2CAN060901

SUBJECT: Response to Request for Additional Information for the
Technical Specification Change to Modify RCS Flow Verification
Arkansas Nuclear One, Unit 2
Docket No. 50-368
License No. NPF-6

RESPONSE TO REQUESTS FOR ADDITIONAL INFORMATION

Figure 1: ANO-2 Reactor Coolant Pump Differential Pressures

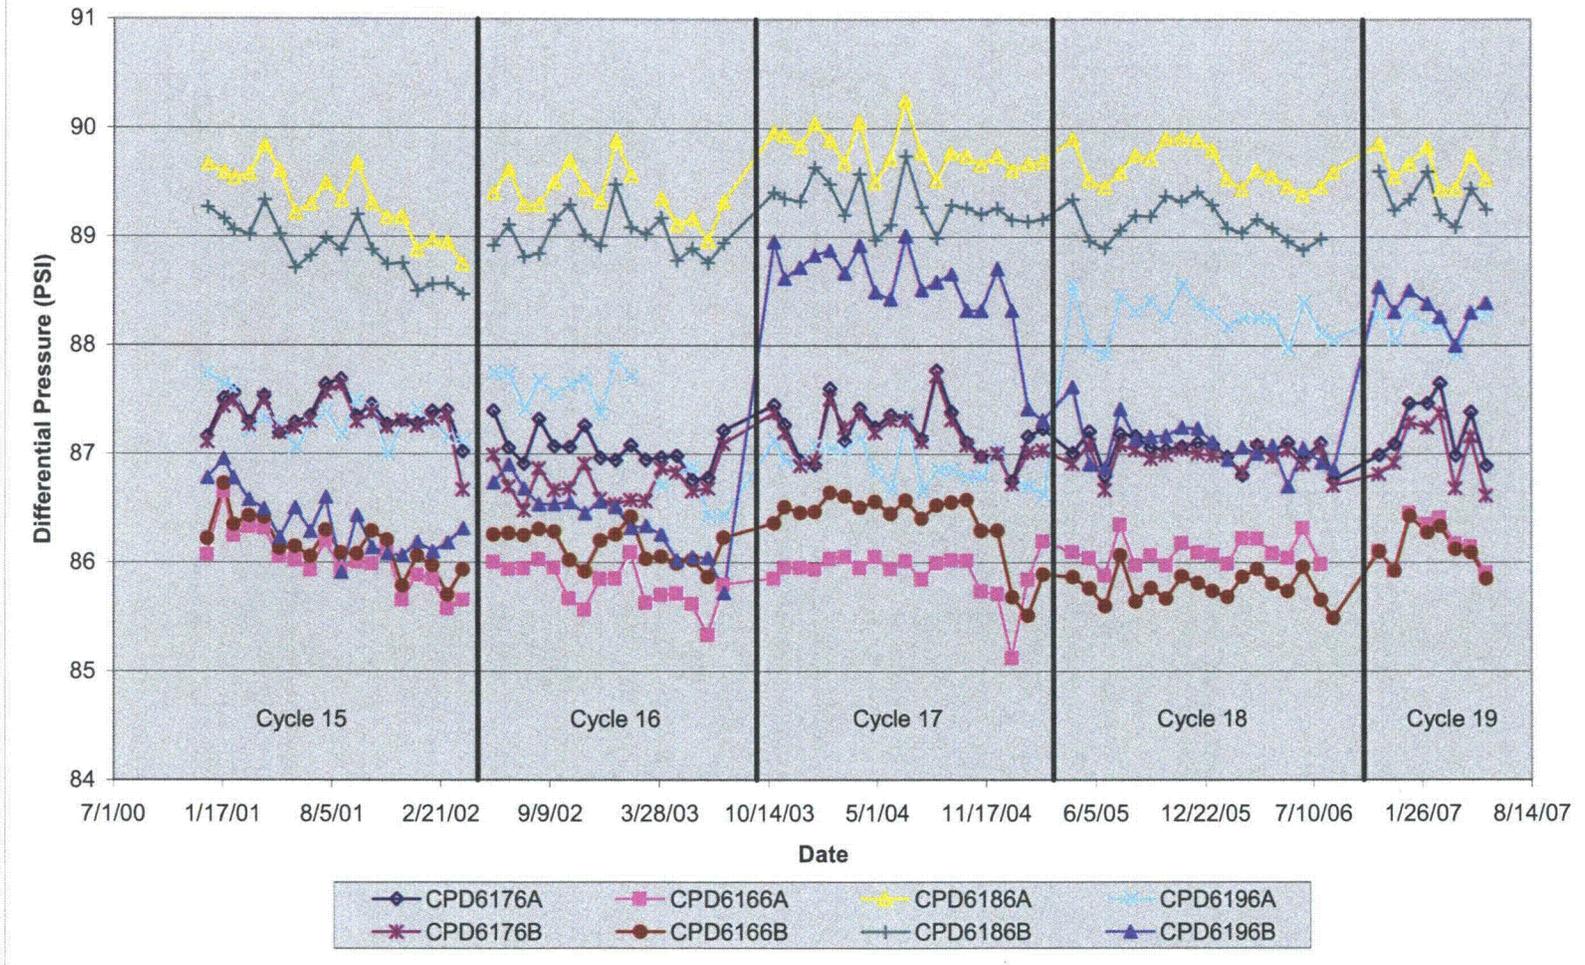
- (b) Provide a discussion with applicable temperature measurement data to substantiate the claim that the calorimetric measured flow rate is “overly” conservative as compared with the COLSS indicated flow rate. The information should include a typical set of hot-leg temperature measurements that show temperature stratification, and a discussion to distinguish effects of uncertainties of RCS hot-leg temperature measurements and temperature stratification phenomena on the calorimetric flow rate determination. Also, quantify the conservatism in terms of a power level reduction in meeting the safety limit DNBR at a lowest value of the measured calorimetric flow rate.**

The relative stability of RCP ΔP instrumentation over time is shown in Figure 1. Although the data does show evidence of instrument calibration errors, there is no indication of degrading pump performance. As part of the analyses performed to support the proposed change, surveillance criteria have been established to ensure calibration errors or instrumentation problems are detected and addressed. Sensitivity analyses have been performed to establish penalties for instrument deviations that will ensure a conservative pump ΔP flow rate.

With respect to pump degradation over time, there is no evidence that this is occurring to any significant degree. The detailed trends of pump ΔP instruments shown in Figure 1 provide no trend indicative of degradation over time. As previously discussed in the response to RAI 1.b, Table 1 shows restoration of the flow rate following installation of RSGs to a level matching or exceeding the plant's original flow rate. The back calculation of hot leg temperature described in response to RAI 2.a also provides evidence that any degradation that has occurred is not significant.

Figure 8: Indicated Temperature vs. Instrument Location
(Cycle 15 Example Shown)

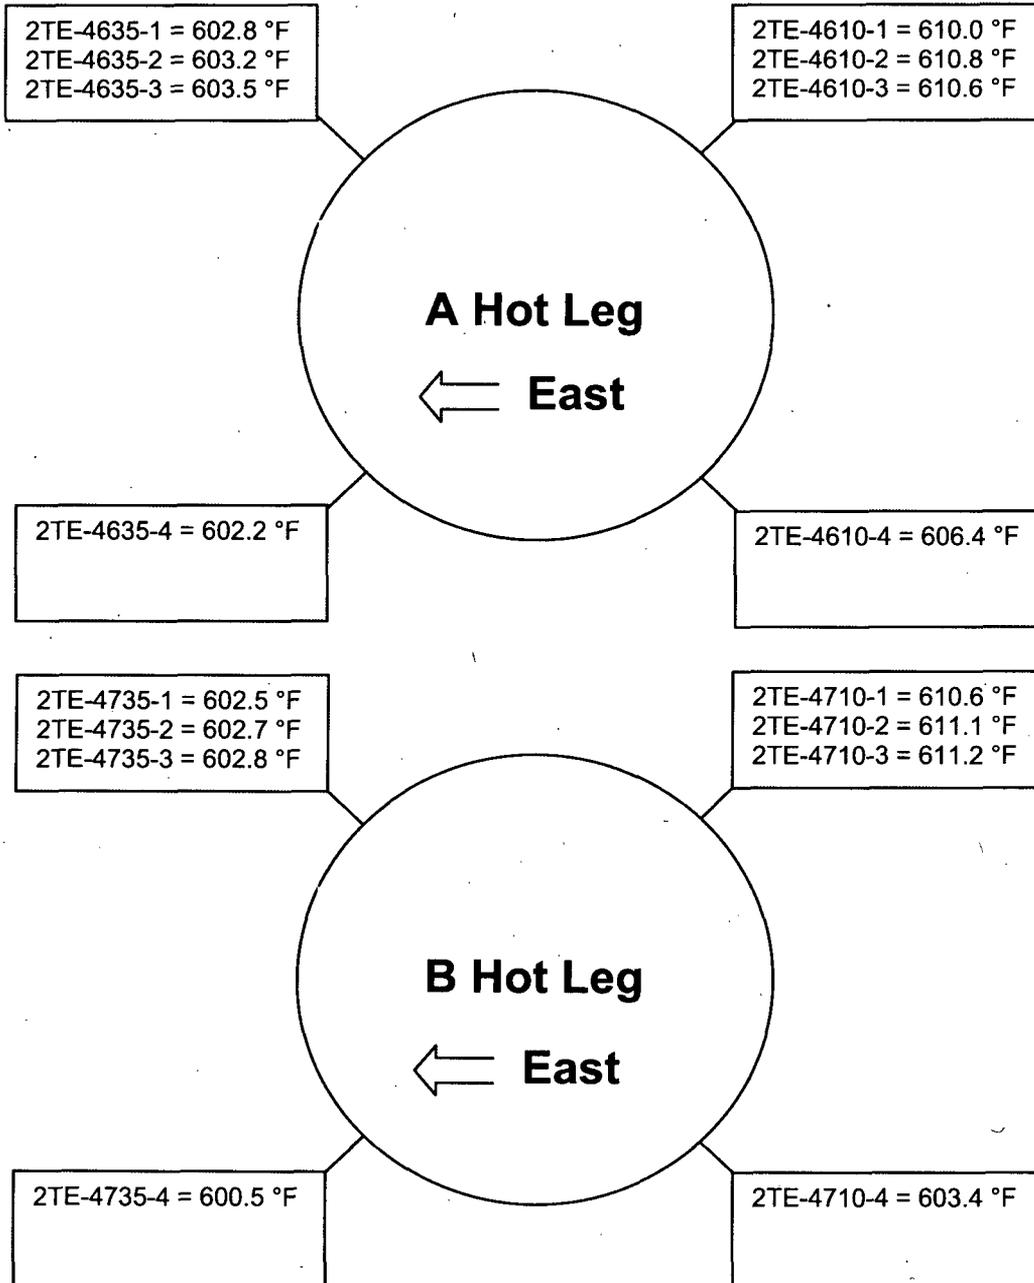
- 1. Paragraph 4 on page 2 to Attachment 1 of letter dated November 13, 2008, indicates that the calorimetric method can be susceptible to the effects of temperature stratification of fluid in the reactor coolant system (RCS) hot-leg. It claims that these effects will result in calorimetric flow measurements being overly conservative as compared with the COLSS indicated flow rate.**
 - (a) Discuss the RCS hot-leg temperature measurements that are used for determining the calorimetric flow rate. The information should include a discussion of locations and numbers of temperature probes for hot-leg temperature measurements, and method of the hot-leg temperature determination.**

The RCS hot-leg temperature instruments currently used in the calorimetric determination of flow consist of eight temperature elements on each hot leg (for a total of sixteen temperature elements). The eight temperature elements on each hot leg are arranged in pairs of two, with the two forming the pair being 90 degrees apart along the circumference of the pipe. On each hot leg, three instrument pairs are positioned on the top half of the pipe and one instrument pair is positioned on the bottom half of the pipe. The pairs on the top half of the pipe have elements approximately 45 degrees to the left and right of the top of the pipe. The single pair on the bottom of each hot leg pipe similarly has elements approximately 45 degrees to the left and right of the bottom. Figure 8 provides an illustration of the arrangement.

Figure 8 is included to illustrate typical temperature readings in relation to instrument location on the hot leg piping. Considering the depth of the thermowell penetration in relation to the diameter of the hot leg piping, the difference in measured temperatures at different locations around the pipe (high temperatures in one particular quadrant of each hot leg) implies that the bulk average temperature can not be reliably inferred. There is no firm basis to assume any given indication is higher or lower than the true bulk average. However, since the true bulk average hot leg temperature is expected to be constant during operation at a constant power level, indications that vary more over the course of a cycle than others are likely to be the least indicative of the real
